ACRS FLUID DYNAMICS SUBCOMMITTEE  
MEETING MINUTES  
JULY 29-30, 1982  
SAN JOSE, CA

PURPOSE: The purpose of the meeting was to discuss potential safety concerns raised by Mr. Humphrey, a former GE employee, regarding the General Electric (GE) pressure suppression containment design and in particular, the Mark III containment.

FIGURE OF PRESSURE MARGINS

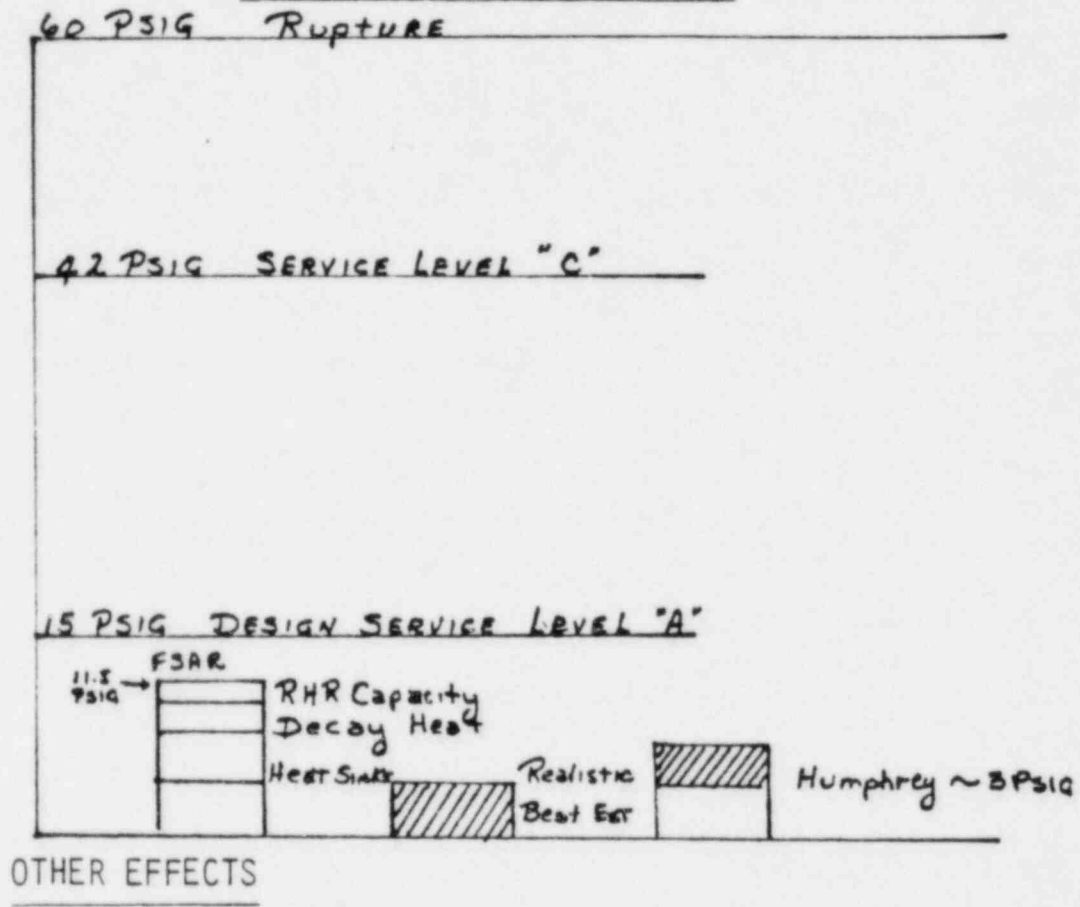
° GE believes ample margin exists to envelope the estimated effects of the Humphrey concerns (Figure 3 & 4). GE specified overall margin factors of between 6 and 24. The Subcommittee expressed skepticism of these margin values, particularly the upper value.

- BEST ESTIMATE OF SUPPRESSION POOL TEMPERATURE  $\sim 160^{\circ}\text{F}$
- SAFETY GRADE CONTAINMENT SPRAYS LIMIT CONTAINMENT PRESSURE AND TEMPERATURE EVEN WITH DRYWELL LEAKAGE
- WITHOUT ACTIVE CONTAINMENT COOLING BUT CREDIT FOR STRUCTURAL HEAT SINKS, OPERATOR HAS APPROXIMATELY 40 HOURS TO ACT BEFORE RUPTURE PRESSURE IS REACHED
